From: Kevin L. Olvany (klo@canandaiguanewyork.gov) <klo@canandaiguanewyork.gov>
Sent: Friday, June 11, 2021 11:48 AM
To: Wendy And Chuck Oylar <chucko@rochester.rr.com>; Shawna Bonshak <sbonshak@townofcanandaigua.org>
Subject: Canandaigua Shores Eiffert/ATL development- St. Rt. 364

I have reviewed the Canandaigua Shores site plan along with the various comments to date and would offer the following additional comments:

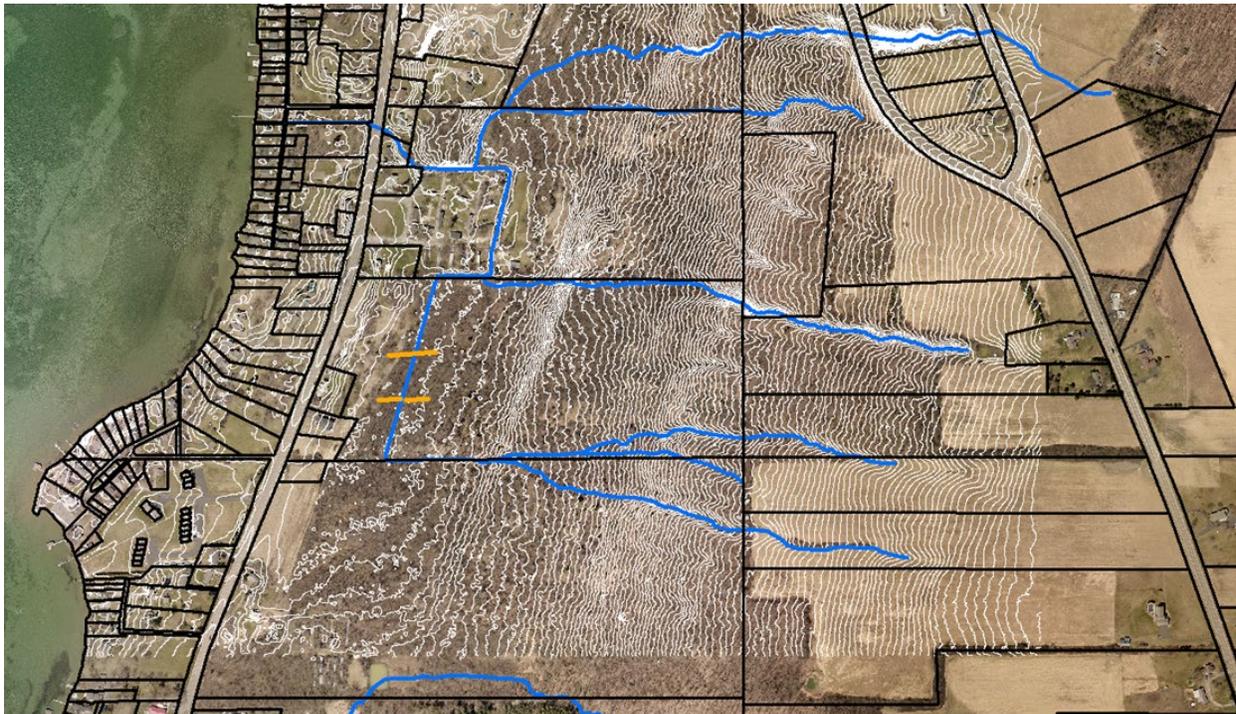
- There needs to be 100 foot buffers on the various stream segments that are shown below. The streams are in blue and the brownish line is the 100 foot distance on the branch that runs south to north. Currently there are Town Houses and a stormwater pond slated for this area.

- There are potential federally regulated wetlands in this low area where the stream system runs south to north. The NWI mapping is very rough and should not be used to determine if there are wetlands. It would be wise to require a wetland delineation along this section
